# Access Compliance Report

## Public Rights-of-Way

### (Pedestrian Signals)

Intersection ID: N/A	Main Street:	Cross Street: N/A	Location: N/A
ADA ID: EBF5E34F88	Signal Type: One Push Button-APS	Overall Compliance: No	Severity Score: BTN 1: N/A BTN 2: N/A No BTN: N/A
Codes/Mitigation Info/Possible Solution		Field Measurements/Component Compliance

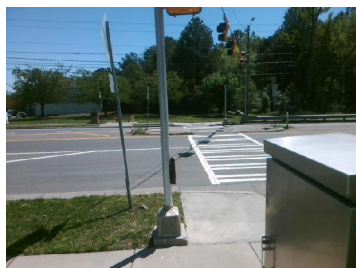
Compliance	Description	Data	Compliance	Description	Data
	Button Count	Button1	N/A	Distant to Additional Button (in)	N/A
	Additional Button Present?	No		Additional Button ID	N/A
N/A	Signal Buttons Required?	N/A	N/A	Additional Ped Posts Required	N/A
	How Many Ped Street Xings?	1		Located In An Island/Median?	No
N/A	B 1 Sign Present?	Yes	N/A	B 2 Sign Present?	N/A
Yes	B 1 Sign Purpose?	Yes	N/A	B 2 Sign Purpose?	N/A
Yes	B 1 Sign Lettering & Contrast?	Yes	N/A	B 2 Sign Lettering & Contrast?	N/A
Yes	B 1 Parallel To XWalk?	Yes	N/A	B 2 Parallel To XWalk?	N/A
Yes	B 1 PAR to Button?	Yes	N/A	B 2 PAR to Button?	N/A
Yes	B 1 PAR to XWalk?	Yes	N/A	B 2 PAR to XWalk?	N/A
Yes	B 1 Clear Floor Space?	Yes	N/A	B 2 Clear Floor Space?	N/A
N/A	B 1 FWD Approach?	Yes	N/A	B 2 FWD Approach?	N/A
N/A	B 1 FWD Approach Constrained?	No	N/A	B 2 FWD Approach Constrained?	N/A
No	B 1 FWD Approach Reach (in)	5.0	N/A	B 2 FWD Approach Reach (in)	N/A

N/A	B 1 FWD Approach Width (in)	N/A	N/A	B 2 FWD Approach Width (in)	N/A
N/A	B 1 FWD Approach Obstruction?	Yes	N/A	B 2 FWD Approach Obstruction?	N/A
N/A	B 1 FWD Approach Obstruction Dist (in)	3.0	N/A	B 2 FWD Approach ObstructionDist (in)	N/A
N/A	B 1 PARA Approach?	Yes	N/A	B 2 PARA Approach?	N/A
N/A	B 1 PARA Approach Constrained?	No	N/A	B 2 PARA Approach Constrained?	N/A
Yes	B 1 PARA Approach Reach (in)	5.0	N/A	B 2 PARA Approach Reach (in)	N/A
N/A	B 1 PARA Approach Width (in)	N/A	N/A	B 2 PARA Approach Width (in)	N/A
N/A	B 1 PARA Approach Obstruction?	Yes	N/A	B 2 PARA Approach Obstruction?	N/A
N/A	B 1 PARA Approach Obstruction Dist (in)	3.0	N/A	B 2 PARA Approach ObstructionDist (in)	N/A
No	B 1 Clear Floor Space Slope (%)	3.0	N/A	B 2 Clear Floor Space Slope (%)	N/A
Yes	B 1 Clear Floor Space XSlope (%)	0.2	N/A	B 2 Clear Floor Space XSlope (%)	N/A
N/A	B 1 PAR Slope (%)	0.8	N/A	B 2 PAR Slope (%)	N/A
Yes	B 1 Height (in)	37.0	N/A	B 2 Height (in)	N/A

Yes B 1 Clear Xing Direction?	ClearlyMarked	N/A B 2 Clear Xing Direction?	N/A
B 1 Crossing Direction	To SE	B 2 Crossing Direction	N/A
Yes B 1 DistanceTo XWalk (in)	46.0	N/A B 2 DistanceTo XWalk (in)	N/A
No B 1 DistanceTo Curb (in)	90.0	N/A B 2 DistanceTo Curb (in)	N/A
Yes B 1 Diameter (in)	2.0	N/A B 2 Diameter (in)	N/A

Possible Solutions: Replace Signal Push Button With APS Button on New Post. Remove & Relocate Sign.
